PLANNING NMA-CHANGE LIST		
ID	Proposed Changes to plans that are 'Non Material'	Reason for 'Amendment'
A	Changes to Common stair towards compliance for general access where a clear landing needs to be provided and to accommodate smoke control. Circulation area and internal doorway to stairs rearranged to adapt corridor aisle. Stairs, structurally stacked for construction leading towards the corridor or lobby next to the stair being provided with a smoke vent and a store area provision on ground level. Rearrangement in plan due to the above visible on the Northeast facade. Window openings, adapted to suit mentioned changes/rearrangement.	Compliance towards Building Regulations, Part-K-Protection from falling, collision and impact and Part-B-Fire safety
B	Changes to Communal lifts and stairs towards compliance for firefighting where a firefighting shaft is required as the building is over 18m and to accommodate smoke control and building services. Circulation area internal doorway to stairs and clear landing for lifts rearranged to adapt corridor aisle. Stairs, structurally stacked for construction leading towards a vertical smoke shaft that opens at roof level with rationalised comm

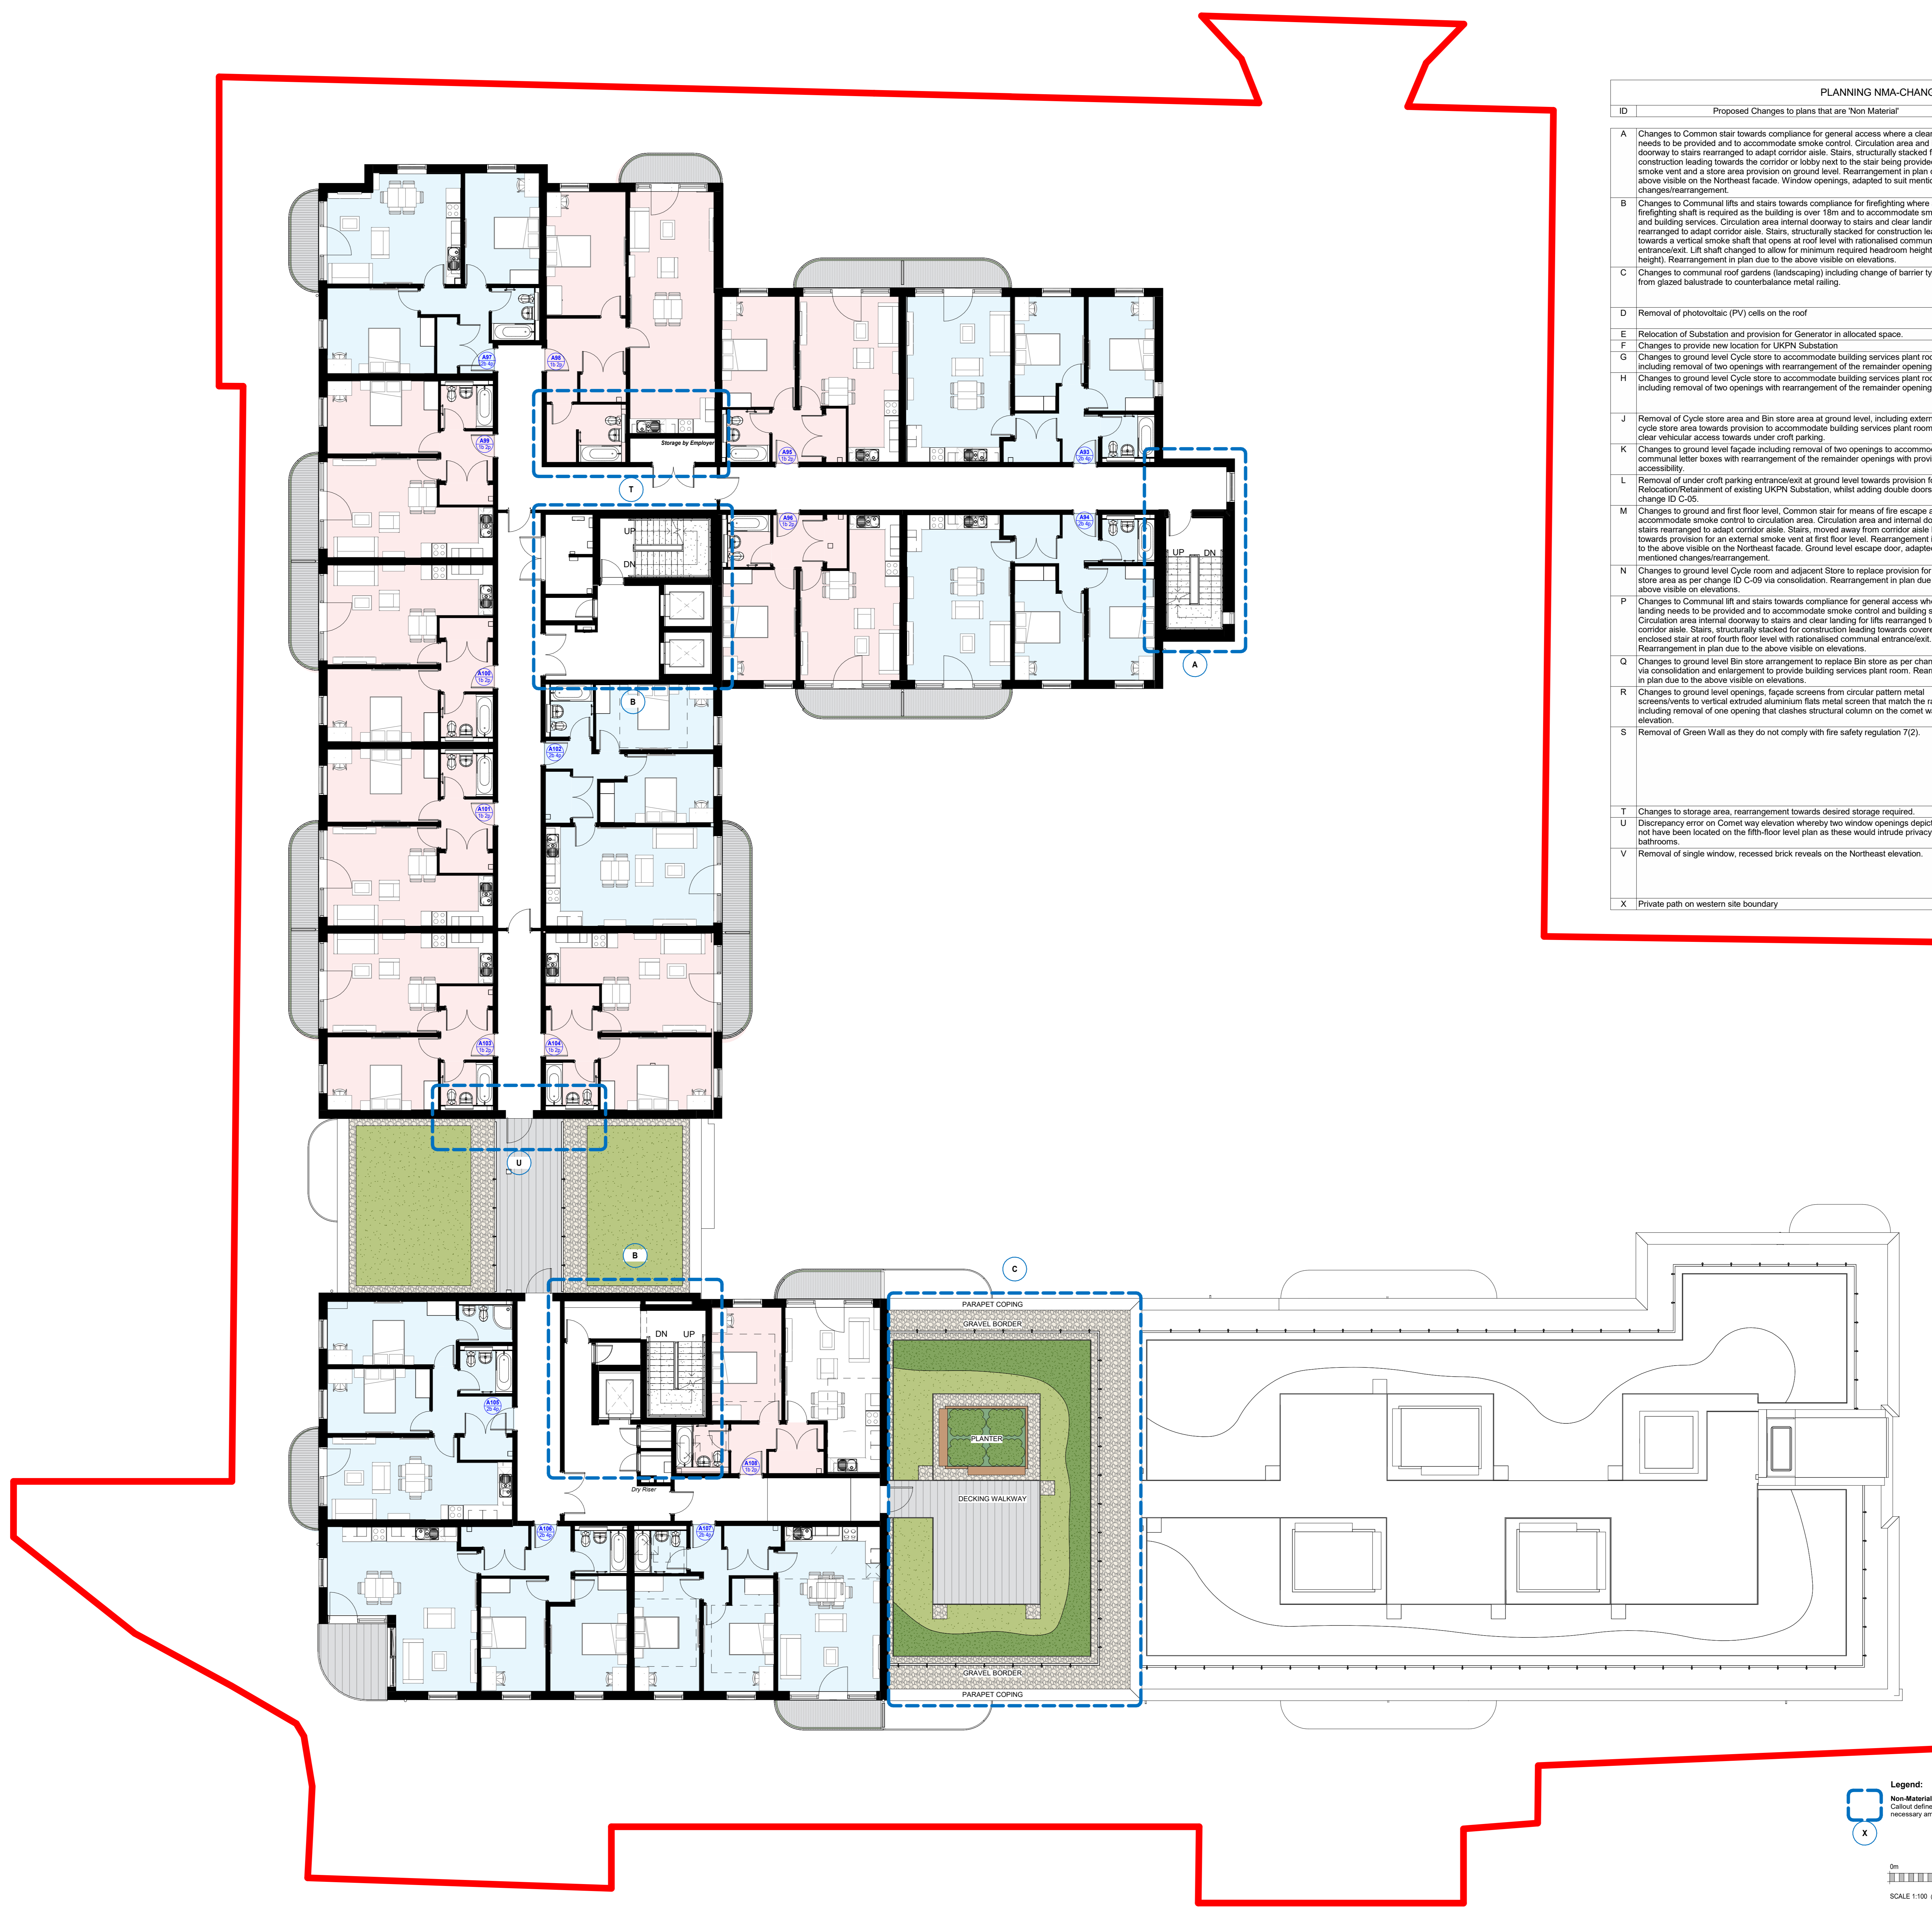
C	Changes to communal roof gardens (landscaping) including change of barrier type (railing) from glazed balustrade to counterbalance metal railing.	To contribute positively towards biodiversity via balance of soft and hard landscaping schemes including provisions for bird and bat boxes, whilst maintaining overall uniformity for railing type.
D	Removal of photovoltaic (PV) cells on the roof	PV was not required as Part L requirement was met using Exhaust Air Heat Pumps.
E	Relocation of Substation and provision for Generator in allocated space.	Provision for separate secluded area for generator
F	Changes to provide new location for UKPN Substation	Provision for future relocation for UKPN Substation
G	Changes to ground level Cycle store to accommodate building services plant rooms including removal of two openings with rearrangement of the remainder openings.	Provision towards Building Services, Secondary LV switch room and Comms room.

H	Changes to ground level Cycle store to accommodate building services plant rooms including removal of two openings with rearrangement of the remainder openings.	Provision towards secure access and splitting into 4 small bin stores to comply with recent updates of having maximum 8 large (1100lrs) receptacles within.
J	Removal of Cycle store area and Bin store area at ground level, including external door in cycle store area towards provision to accommodate building services plant room including clear vehicular access towards undercroft parking.	Provision towards Building Services, Primary LV switch room and vehicular access towards undercroft parking.
K	Changes to ground level facade including removal of two openings to accommodate communal letter boxes with rearrangement of the remainder openings with provision for accessibility.	Provision towards communal letter boxes
L	Removal of undercroft parking entrance/exit at ground level towards provision for Relocation/Retainment of existing UKPN Substation, whilst adding double doors as per change ID C-05.	Provision towards single point of entry/exit for undercroft parking and towards relocation/retainment of existing UKPN Substation mentioned in change ID-E.

M	Changes to ground and first floor level, Common stair for means of fire escape and to accommodate smoke control to circulation area. Circulation area and internal doorway to stairs rearranged to adapt corridor aisle. Stairs, moved away from corridor aisle leading towards provision for an external smoke vent at first floor level. Rearrangement in plan due to the above visible on the Northeast facade. Ground level escape door, adapted to suit mentioned changes/rearrangement.	Compliance towards Building Regulations, Part-B-Fire safety.
N	Changes to ground level Cycle room and adjacent Store to replace provision for Cycle store area as per change ID C-09 via consolidation. Rearrangement in plan due to the above visible on elevations.	Provision towards replacement of removed cycle store mentioned in change ID-J.
P	Changes to Communal lift and stairs towards compliance for general access where a clear landing needs to be provided and to accommodate smoke control and building services. Circulation area internal doorway to stairs and clear landing for lifts rearranged to adapt corridor aisle. Stairs, structurally stacked for construction leading towards covered and enclosed stair at roof fourth floor level with rationalised communal entrance/exit. Rearrangement in plan due to the above visible on elevations.	Compliance towards Building Regulations, Part-K-Protection from falling, collision and impact, Part-B-Fire safety and Provision for stair enclosed/walkway that is directly covered.

Q	Changes to ground level Bin store arrangement to replace Bin store as per change ID C-09 via consolidation and enlargement to provide building services plant room. Rearrangement in plan due to the above visible on elevations.	Provision towards replacement of removed Bin store mentioned in change ID-J and provision for BCW Tank room
R	Changes to ground level openings, facade screens from circular pattern metal screens/vents to vertical extruded aluminium flats metal screen that match the railing type, including removal of one opening that clashes structural column on the corner way elevation.	To maintaining overall architectural uniformity and structural framing.
S	Removal of Green Wall as they do not comply with fire safety regulation 7(2).	Regulation 7(2), requires all residential blocks with top-storey heights over 18m to have all materials which become part of an external wall or specified attachment (e.g., balconies) to achieve class A2-s1, d0 or class A1, except for materials which are exempt as per regulation 7(3). Additionally, membranes used as part of external wall construction above ground should achieve a minimum of class B-s3, d0.

T	Changes to storage area, rearrangement towards desired storage required.	Provision towards desired storage required.
U	Discrepancy error on Comet way elevation whereby two window openings depicted would not have been located on the fifth-floor level plan as these would intrude privacy for the bathrooms.	Discrepancy error
V	Removal of single window, recessed brick reveals on the Northeast elevation.	The recessed brick reveals is towards the left of a single pane window for levels 1-4, whilst it changes to a double pane for level 5. To maintain architectural uniformity, we have detailed a constant double pane window for all levels.
X	Private path on western site boundary	For Façade maintenance MEWP access.
